# UNITED STATES PATENT AND TRADEMARK OFFICE

APPLICATION NO.	FILING DATE	FIRST NAMED INVENTOR	ATTORNEY DOCKET NO.	CONFIRMATION NO.
10/002,141	12/05/2001	Alexander Beeck	033275-316	3862

**Office Action Summary**

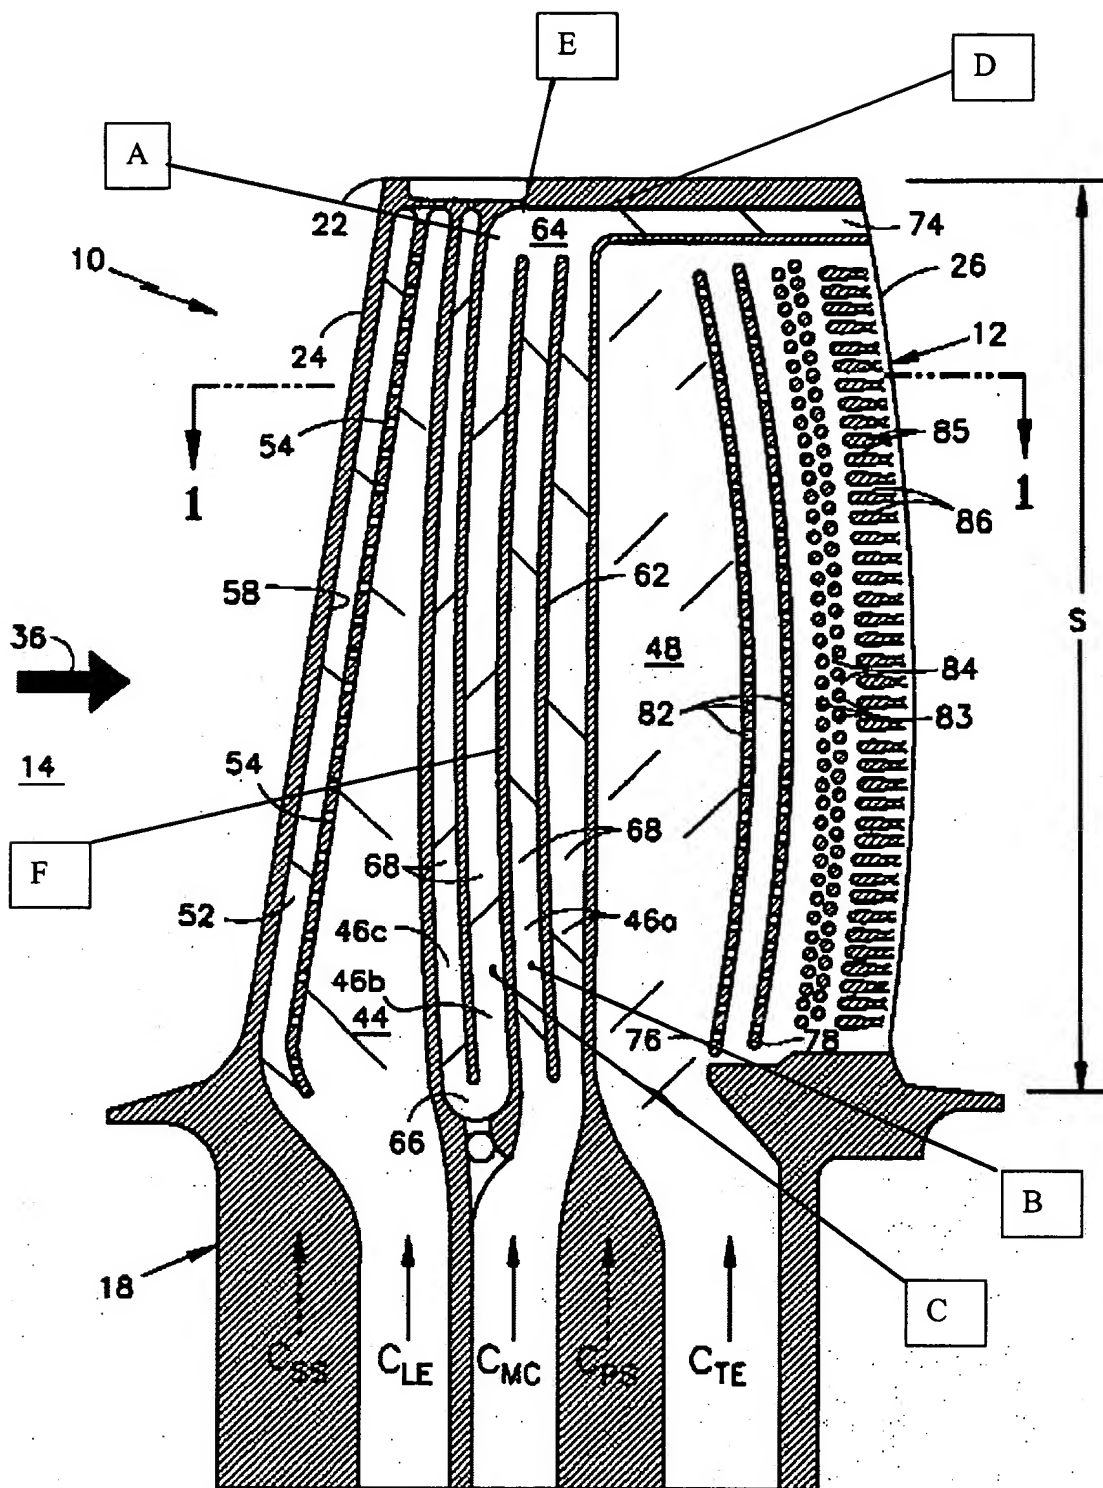
Claims 8, 10-12, and 14-15 are rejected under 35 U.S.C. 102(b) as being anticipated by Krause 5,931,638. Please refer to the annotated figure below. Krause discloses a component 10 of a fluid flow machine, comprising a coolant passage comprising a curved flow section A, a first section B through which a cooling medium flows toward the curved flow section, and a second section C adjacent the first section through which the cooling medium flows away from the curved flow section, and a second passage 74 comprising an unnumbered inspection aperture, the inspection aperture including a top wall D flush with a wall E of the coolant passage, with the second passage branching off the coolant passage at the curved flow section and being arranged

as a tangent to the curved flow section, wherein both of the first section of the coolant passage and the second passage are partially defined by a common surface F. The inspection aperture is arranged and dimensioned to enable introduction of a borescope through the inspection aperture and the second passage. The first section B may be considered as a single first section, through which the cooling medium flows from the coolant passage into the second passage. The coolant passage further comprises a second section C arranged downstream of the curved section, with the coolant passage and the second passage being arranged such that particles entrained in the cooling medium pass through the first section, through the second passage and are discharged through the inspection aperture, while the cooling medium which is relatively free of particles flows through the second section. The second section is adjacent the first section. The recitation of the inspection aperture being arranged and dimensioned to enable introduction of a borescope through the inspection aperture and the second passage does not define over Krause, because these limitations are a function of the size of the borescope, and the size of the borescope would determine whether or not it would be able to be introduced into the inspection aperture. A miniaturized borescope having a tiny diameter would be capable of being introduced into the inspection aperture.

Claims 11-12 and 14-15 are also rejected under 35 U.S.C. 103(a) as being unpatentable over Krause 5,931,638 in view of Liang 5,975,851. Please refer to the annotated figure above. Krause discloses a component 10 of a fluid flow machine, comprising a coolant passage comprising a curved flow section A, a first section B through which a cooling medium flows from the coolant passage into a second passage 74, comprising an unnumbered inspection aperture, the inspection aperture including a top wall D flush with a wall E of the coolant passage, with the second passage branching off the first section of the coolant passage at the curved flow section and being arranged as a tangent to the curved flow section. The inspection aperture is arranged and dimensioned to enable introduction of a borescope through the inspection aperture and the second passage. The coolant passage further comprises a second section C arranged downstream of the curved section, with the coolant passage and the second passage being arranged such that particles entrained in the cooling medium pass through the first section, through the second passage and are discharged through the inspection aperture, while the cooling medium which is relatively free of particles flows through the second section. The
